AMENDED BY STAFF 8/18/87  
**CITY PLANNING COMMISSION**

**APPLICATION:** A. Negative Declaration  
B. Special Permit to allow 100 percent office use for three buildings totaling 159,200± sq. ft. on 10.0 vacant acres in the M-1 zone.

**PROPOSAL:** The applicant is requesting the necessary entitlements to construct three 2-story office building.

**APPLC. NO.** P87-266 **MEETING DATE** August 27, 1987 **ITEM NO.** 9

SITE PLAN

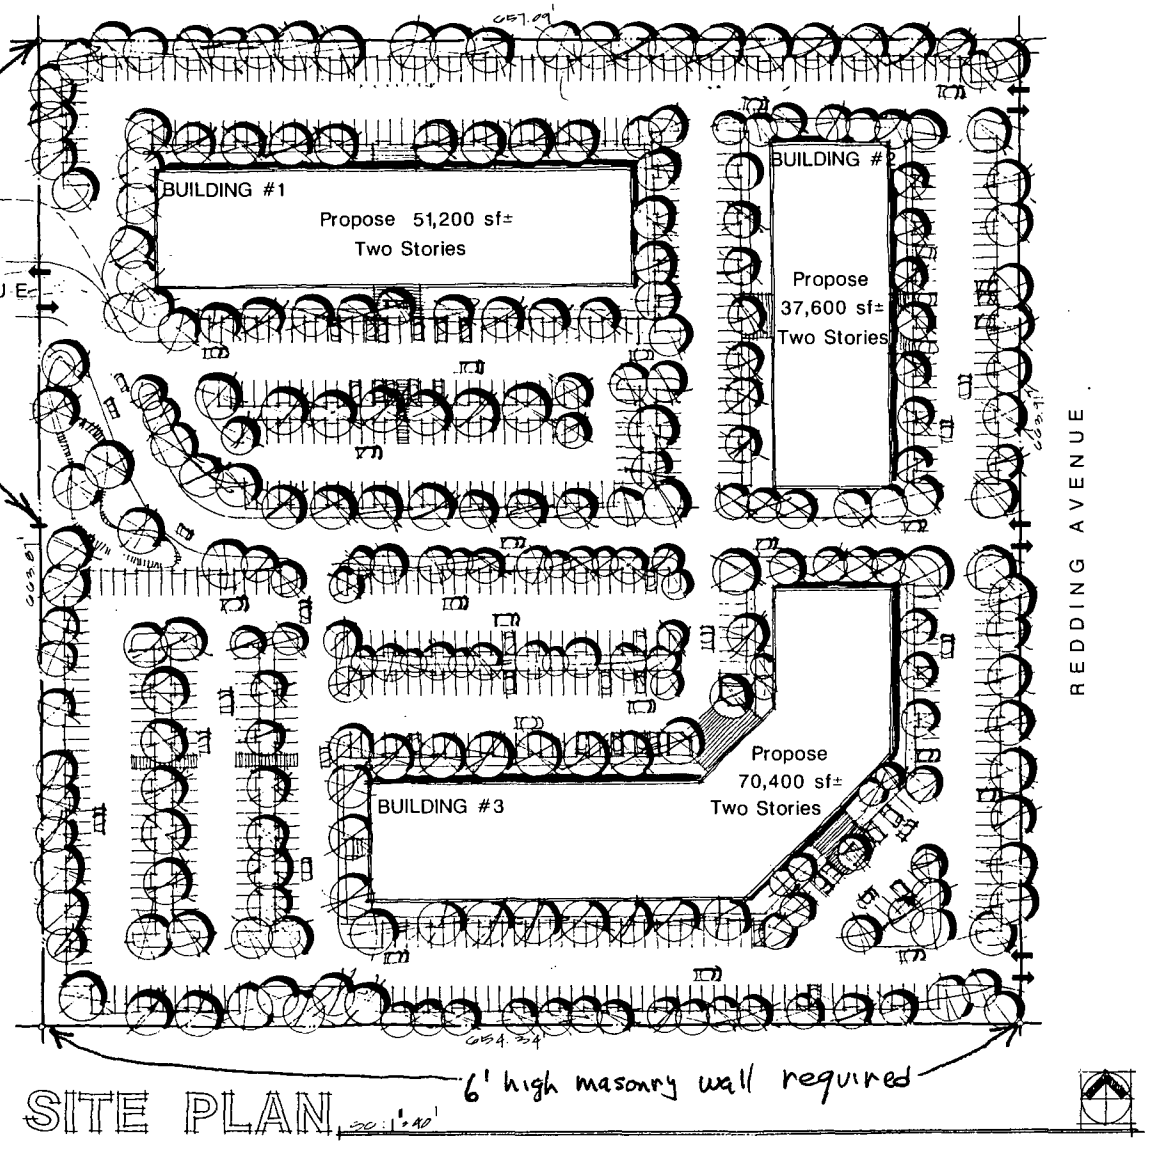
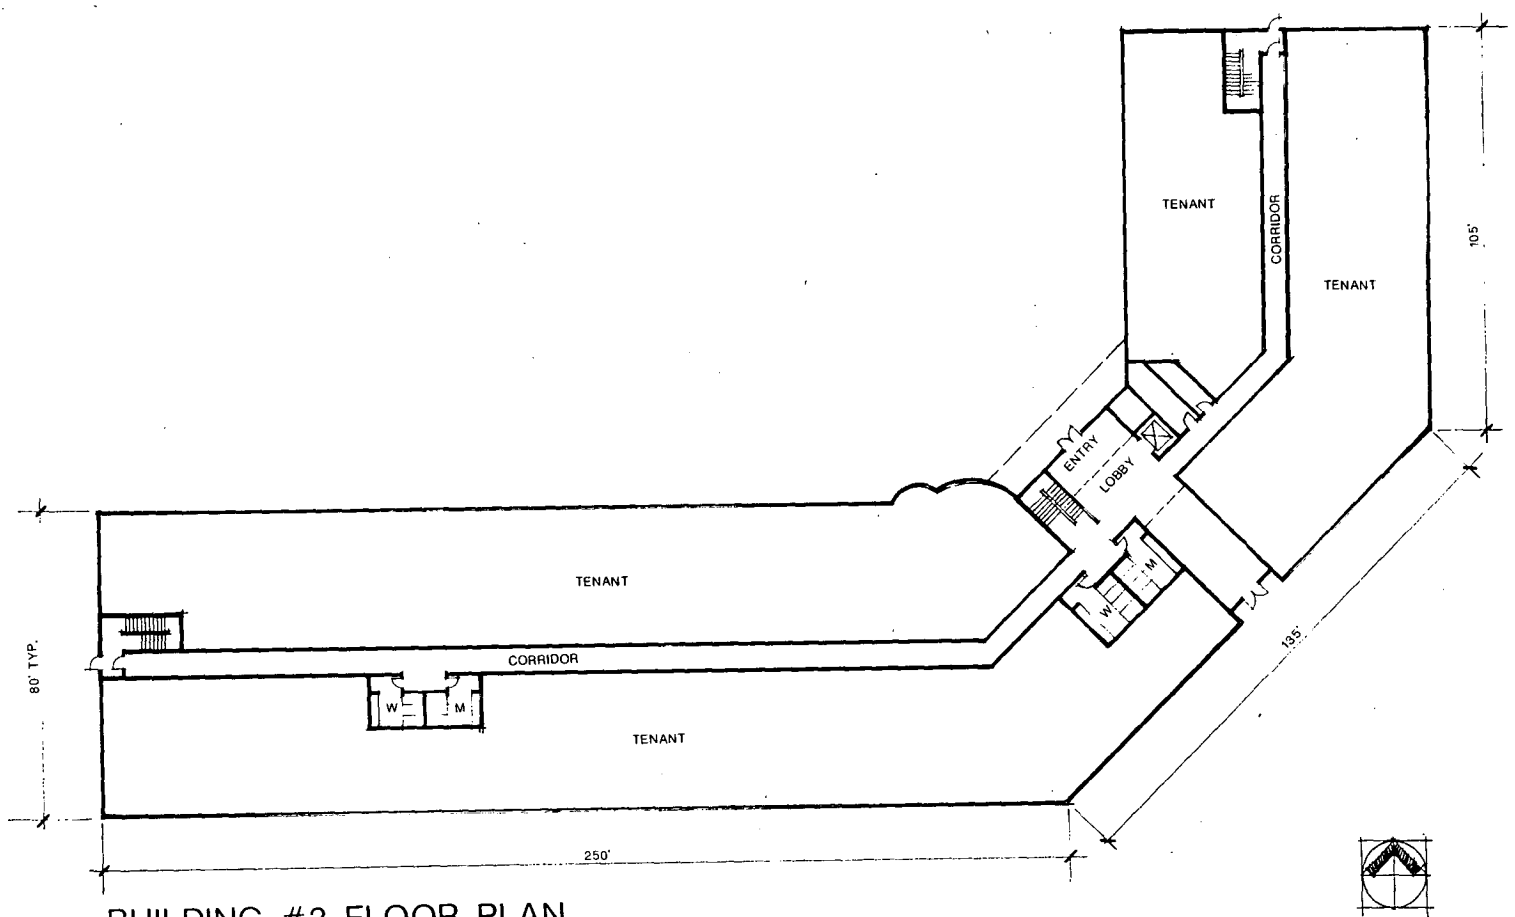
The site plan does not show the location of trash enclosures or the required Class I, II, bicycle storage lockers. The site plan needs to be revised to show the locations of the trash enclosures and bicycle storage lockers.

The building footprints proposed on the site plan do not precisely match the proposed building elevations. Staff recommends the site plan be revised to show more precise building footprints consistent with the proposed elevations.

There is a multiple Family (R-3) zone located along a portion of the west property line (see site plan). A six foot high solid masonry wall will be required along a portion of the west property line (see site plan).

Based upon the above comments, staff recommends revised site and elevations plans be submitted for the review and approval of the Planning Director prior to the issuance of a building permit.

- \* 12. A revised site plan showing ~~the alignment~~ *a cul-de-sac at 4th Avenue or extension of 4th Avenue or extension of 4th Avenue to Redding Avenue* shall be submitted to Planning Staff for review and approval prior to the issuance of building permits. *Design shall comply with Public Works Department requirements.*

13. Dedicate right-of-way necessary to construct improvements and extend 4th Avenue to Redding Avenue. Construction will be to City Standards.
14. A six foot high solid masonry wall shall be constructed on the portion of the west property line abutting the adjacent R-3 zone (see site plan).

15. A revised site plan indicating the alignment of Broadway to Redding Avenue shall be submitted to Planning Staff for review and approval prior to issuance of a building permit.

ELEVATIONS BUILDINGS 1 & 2

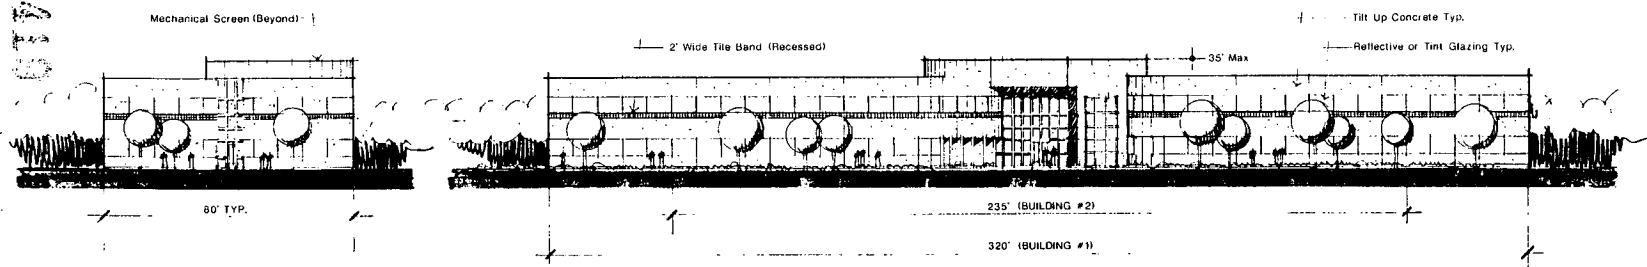
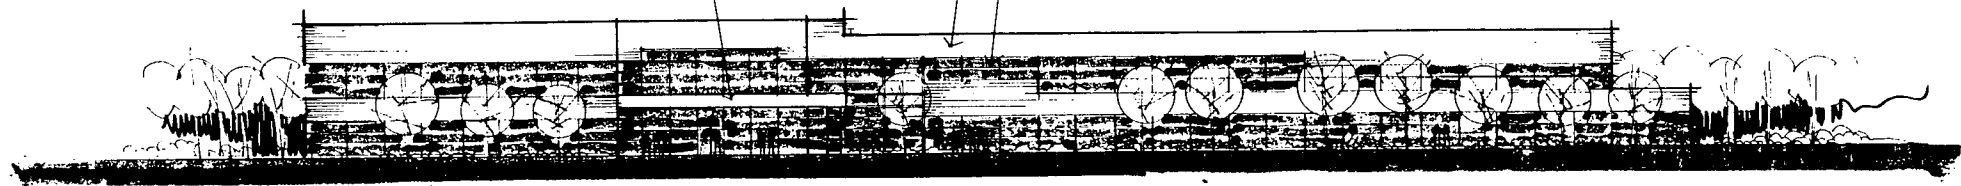
The elevations submitted show concrete tilt-up panels, tint or reflective glass and recessed entry or entry canopy. However, the elevations submitted do not provide sufficient detail and are more conceptual rather than specific. Staff has concerns with the flat lineal facade and would prefer to see more movement both horizontally and vertically in all elevations.

The proposed design of the entry areas for both front and rear of the buildings are different. Staff recommends these entry ways be redesigned so they are the same.

Staff recommends all roof top equipment be screened from public view.

The exterior building materials proposed are generally acceptable. However, staff recommends the additional use of brick, tile, insets or other textural elements be added to the proposed building materials.
